HISTORIC AND DESIGN REVIEW COMMISSION

HDRC CASE NO: 2025-094
ADDRESS: 503 E GUENTHER ST
LEGAL DESCRIPTION: NCB 941 BLK 4 LOT E IRR 262FT OF 1 & E IRR 275FT OF 2
ZONING: RM-4, H
CITY COUNCIL DIST.: 1
DISTRICT: King William Historic District
APPLICANT: Daniel Cruz/Design Coop
OWNER: Seema Izfar/IZFAR SEEMA
TYPE OF WORK: Construction of a rear accessory structure
APPLICATION RECEIVED: April 10, 2025
60-DAY REVIEW: June 9, 2025
CASE MANAGER: Caitlin Brown-Clancy
REQUEST:

The applicant is requesting a Certificate of Appropriateness to construct a one-story rear accessory structure measuring approx. 392 sf at the SE corner of the historic home in the rear yard behind the existing privacy fence featuring a pool cabana and outdoor kitchen.

DRAWN: KK
CHECKED: DC
APPROVED:
DATE: APRIL 10, 2025
SHEET NO.
PROPOSED SITE PLAN
PROPOSED FLOOR PLAN

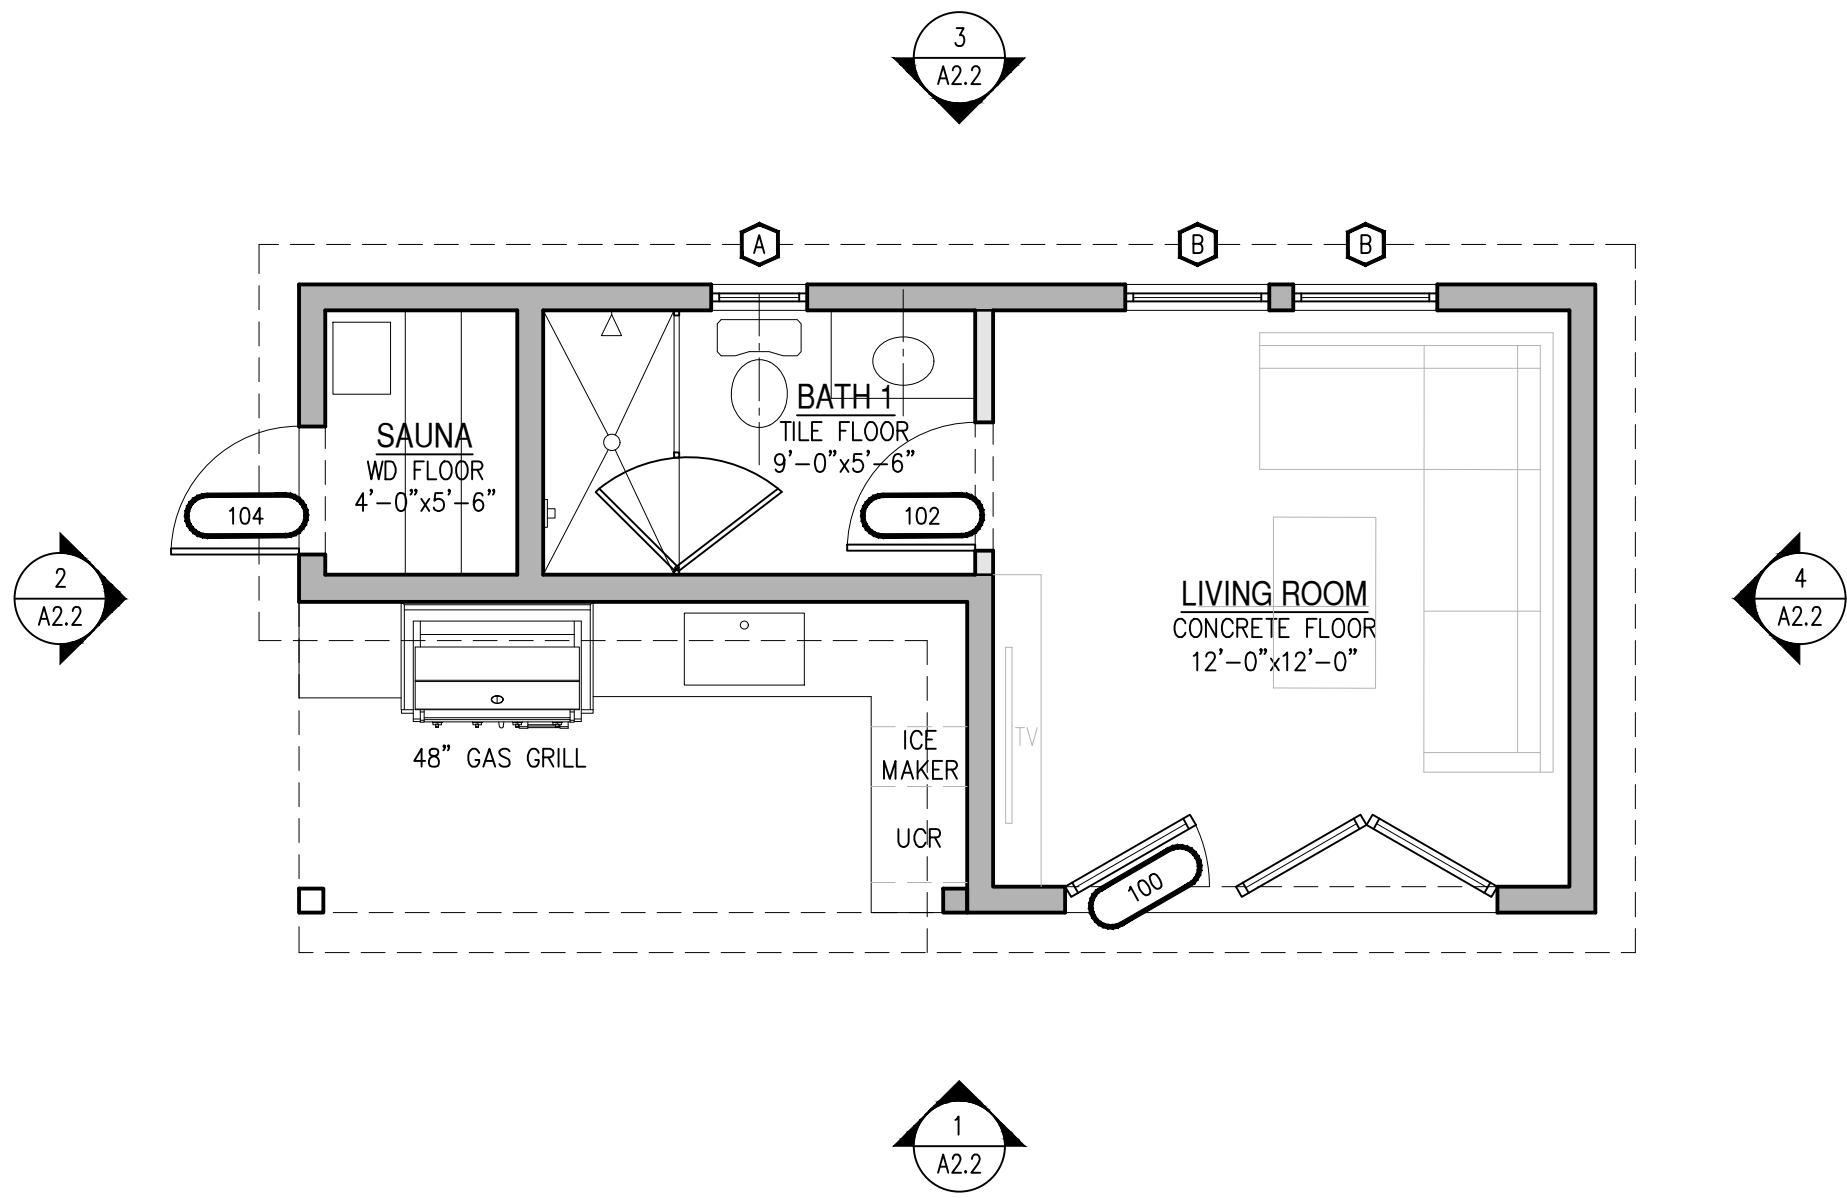
- b. SETBACK – The applicant is proposing to situate the new construction at the SE corner of the existing historic home in the rear yard behind the existing privacy fence. Guidelines for New Construction 5.B.ii states that outbuildings are most typically located at the rear of the lot, behind the principal building. Staff finds the proposed setback appropriate.

1 EXTERIOR ELEVATION: FRONT ELEVATION
SCALE: 1/4" = 1'-0"

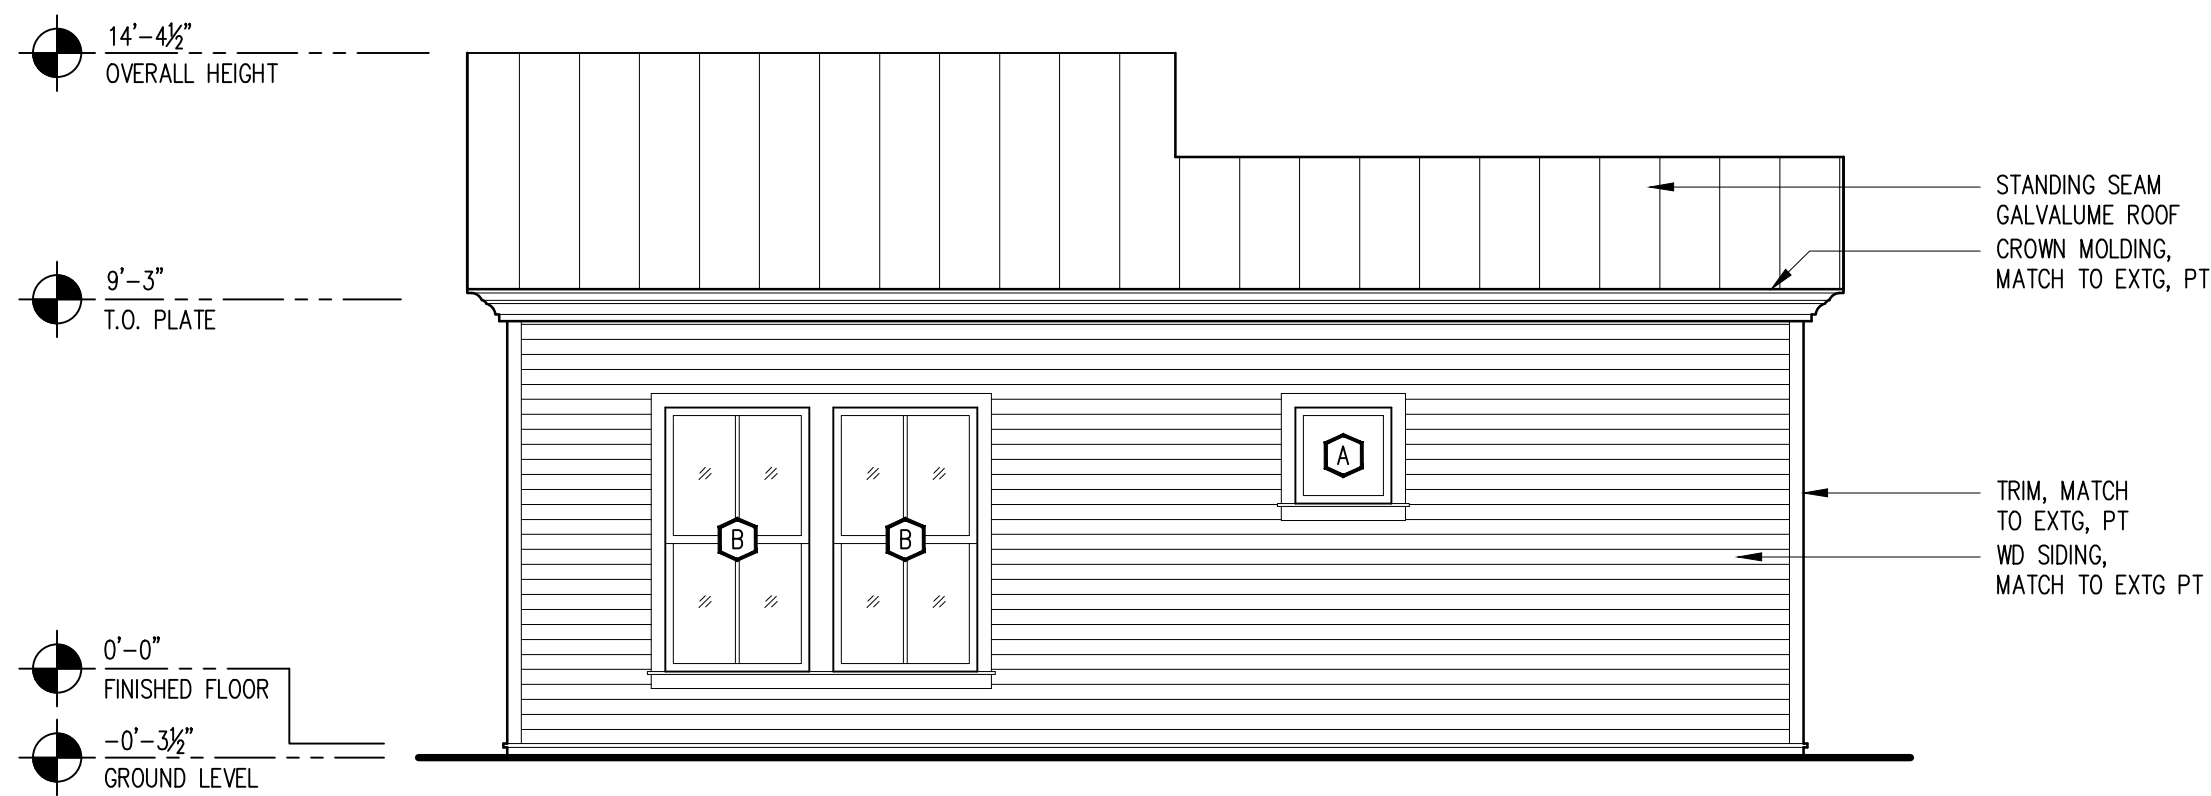
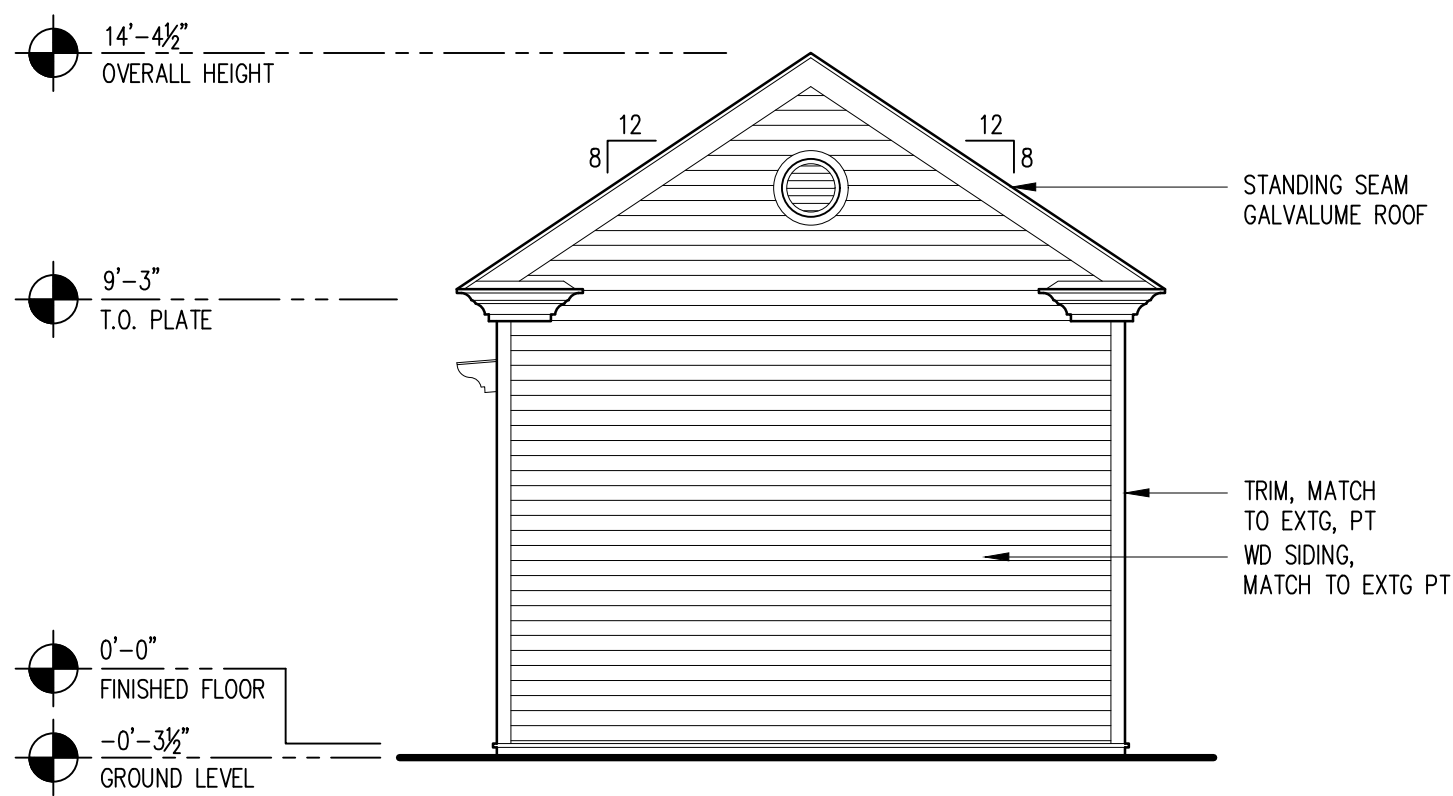
- c. MASSING AND FORM – The applicant is proposing to construct an approx. 392 sf, single-story structure which 14'4" at the highest ridge. Guideline 5.A.i states that new outbuildings should be visually subordinate to the principal historic structure in terms of their height, massing, and form. The primary structure's building footprint measures approx. 3,000 sf and approx. 25'0" at the highest ridge. Staff finds the proposed massing consistent with the Guidelines.

- d. MATERIALS – The applicant is proposing to clad the new construction in wood siding to match the existing rear addition, as well as using a standing seam metal roof in keeping with the primary structure. While the applicant hasn't submitted exact material specifications, staff generally finds the proposed materials appropriate but finds the applicant should submit all material specifications to include siding, doors and windows to staff for review prior to the issuance of a COA.

- e. ARCHITECTURAL DETAILS – The applicant has proposed a design that features historic details including exposed rafters, wooden columns with traditional capital and base, and two over two sashed windows. Staff finds the character of the new construction complements the primary structure and is consistent with the Guidelines.

1. That the applicant installs a fully wood or clad wood window that meets staff's standard window stipulations and submits updated specifications to staff for review and approval. The windows should feature an inset of two (2) inches within facades and should feature profiles that are found historically within the immediate vicinity. Meeting rails must be no taller than 1.25" and stiles no wider than 2.25". White manufacturer's color is not allowed, and color selection must be presented to staff. There should be a minimum of two inches in depth between the front face of the window trim and the front face of the top window sash. This must be accomplished by recessing the window sufficiently within the opening or with the installation of additional window trim to add thickness. Window trim must feature traditional dimensions and architecturally appropriate sill detail. Window track components must be painted to match the window trim or concealed by a wood window screen set within the opening.

2. That the applicant install a standing seam metal roof featuring panels that are 18 to 21 inches wide, seams that are 1 to 2 inches high, a crimped ridge seam, and match the current finish or a standard galvalume finish. Panels should be smooth without striation or corrugation. Ridges are to feature a double-munch or crimped ridge configuration; no vented ridge caps or end caps are allowed. All chimney, flue, and related existing roof details must be preserved. An inspection must be scheduled with OHP staff prior to the start of work to verify that the roofing material matches the approved specifications.

3. That the applicant submit all material specifications to include siding, doors and windows to staff for review prior to the issuance of a COA.
